ORIGINATION FORM

Proposed Revisions to a Standard Plans Index
(Please provide all information — Incomplete forms will be returned)

Index Number: 700-011

Index Title: Single Column Cantilever Ground Mounted Sign

SECTION C-C

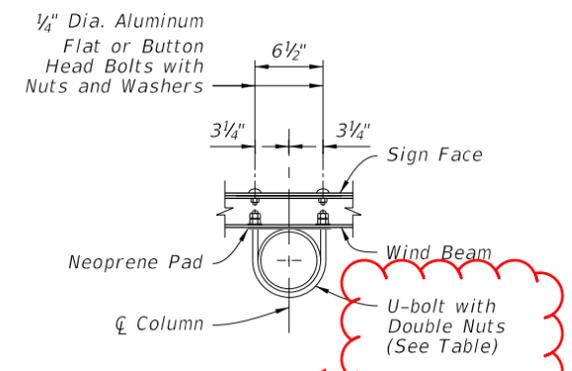
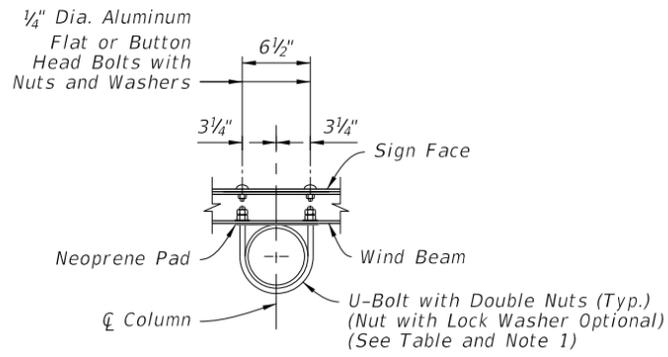
Sheet 1: Added nut and lock washer option to SECTION C-C.

Districts have commented that double nuts are more difficult to install with negligible safety benefits.

ADDED: Nut and Lock Washer Option
